RE: COMPLIANCE SUBMISSION (NO. 3) IN RELATION TO LIDL DISCOUNT FOODSTORE ANCHORED DEVELOPMENT AT MAIN STREET UPPER, NEWCASTLE, CO. DUBLIN

SOUTH DUBLIN COUNTY COUNCIL PLANNING REGISTER REFERENCE: SD22A/0312

2.0 RESPONSE RE. BUILDINGS C+D WINDOWS TO HISTORIC FAÇADES

04 Building D - Proposed Rear (South) Elevation
PA 303 1:50

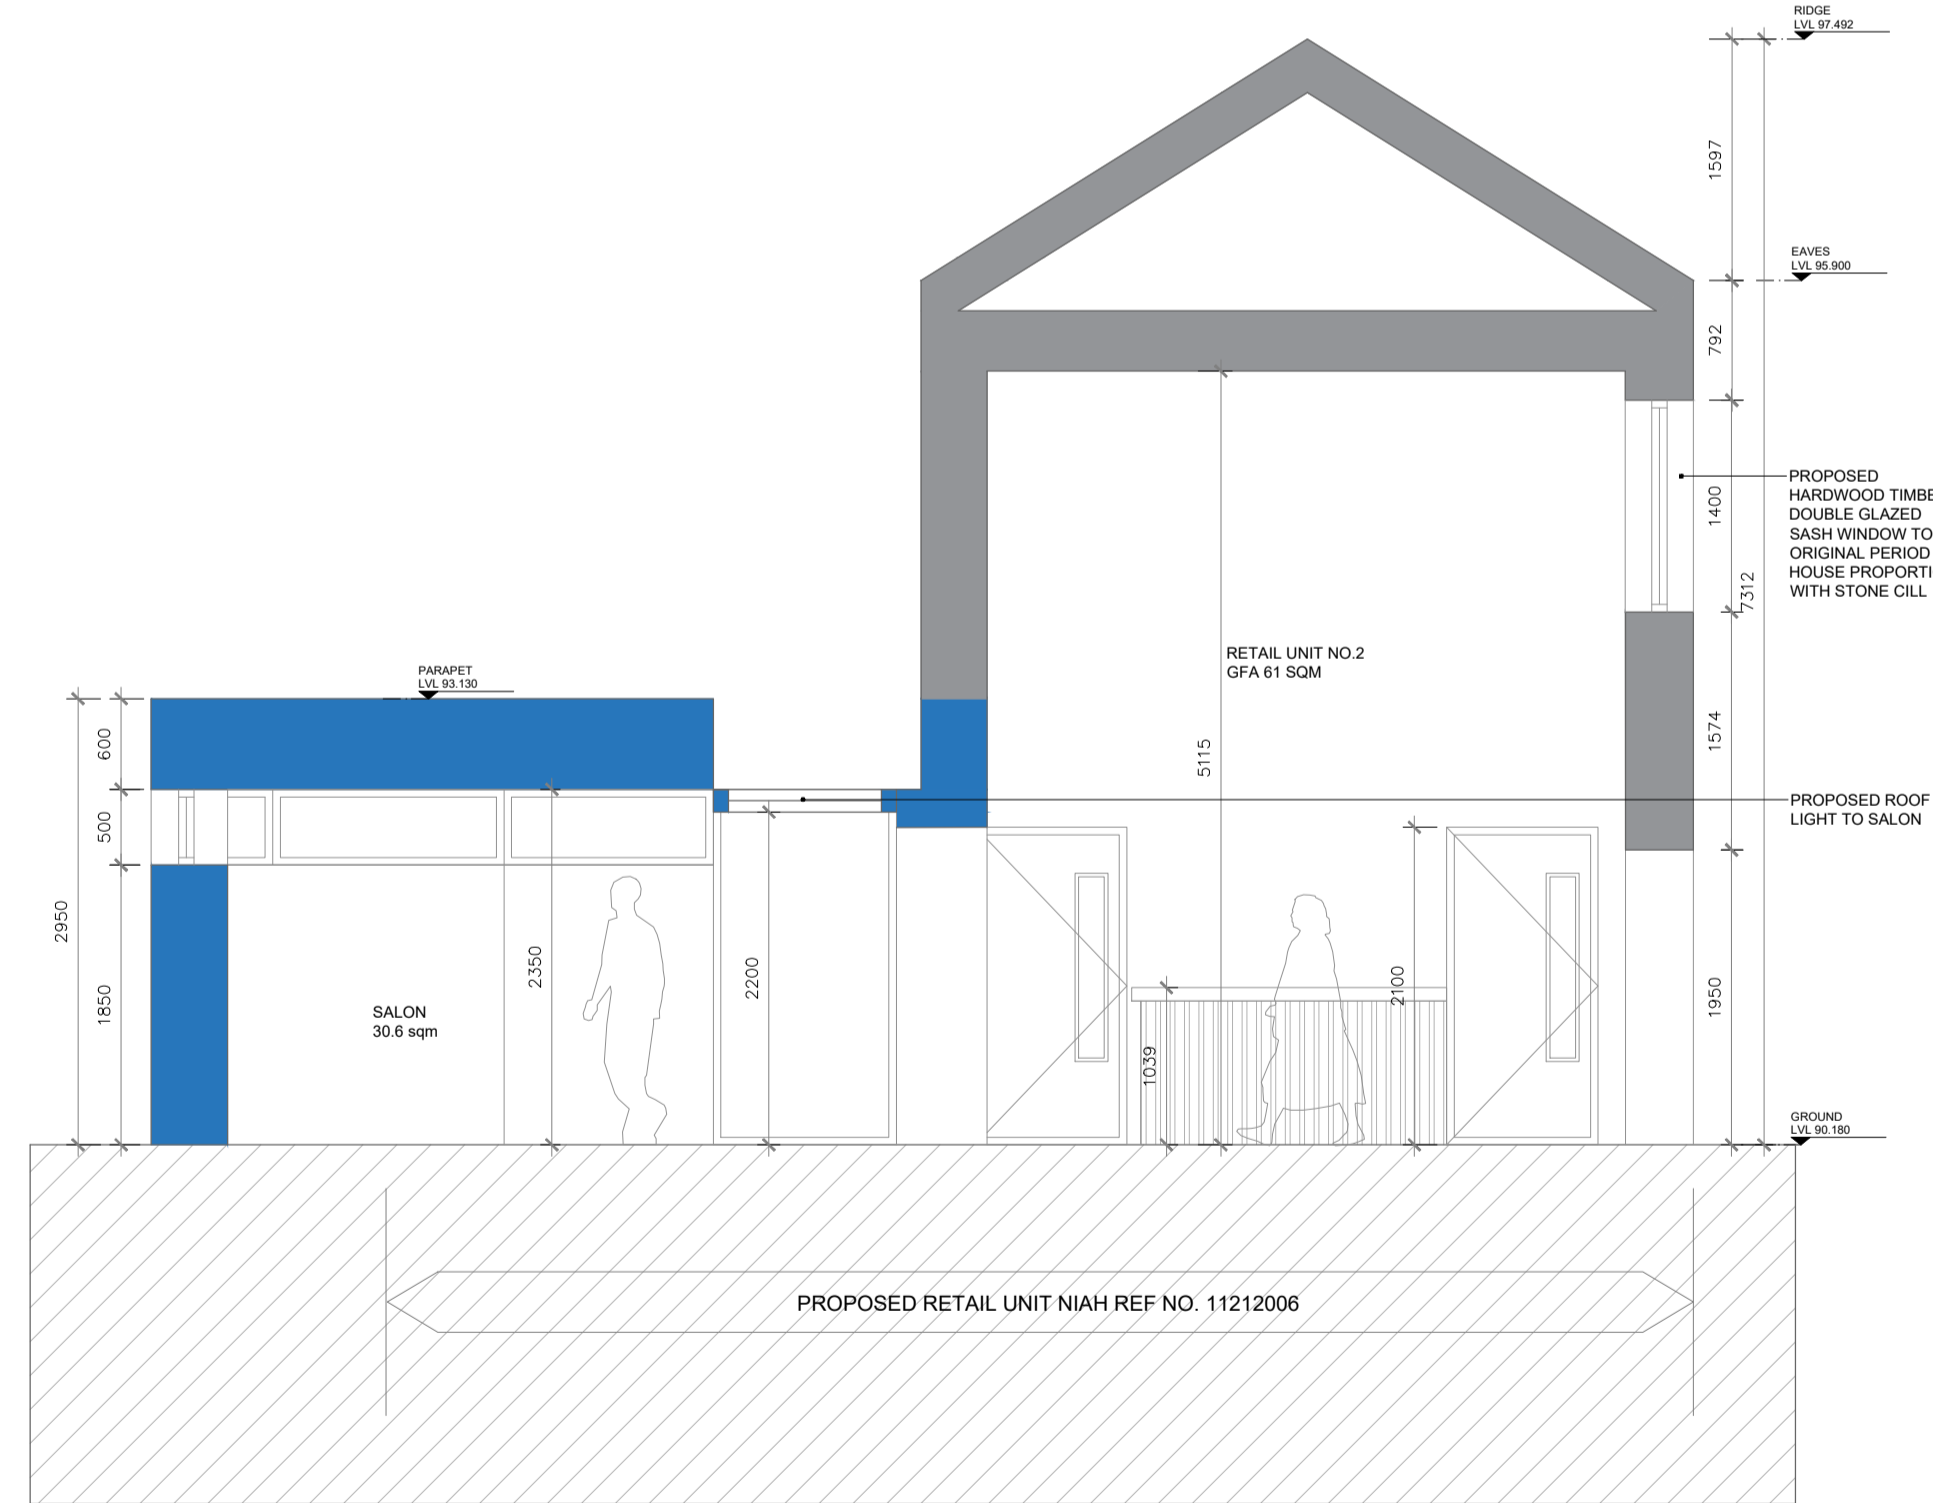
There was just one item that I would like to seek further clarification on and that is the new sash windows proposed to the historic building façade. It is important that if historic window types are to be reinstated that this is done with windows that will match the original profile and material type to ensure they are historically correct and so that you don't end up with a thick unit and window that looks small and reduces natural light. The finish colour should match in with the colour palette and therefore the sashes should be painted in a dark colour rather than white as shown. I would argue however that if there is no evidence of the window type at this location that modern windows could be considered to tie in with the overall design of the Café/retail unit and Buildings C+D). I would therefore advise that this item is addressed or clarified.

We enclose drawings and details (see Appendices B, C & E) illustrating the proposed window finishes and specification.

Rev.	Description	Date	Initials
A	Metal Lid Sign added	02/02/23	MP
B	Windows type uploaded	12/03/24	EL
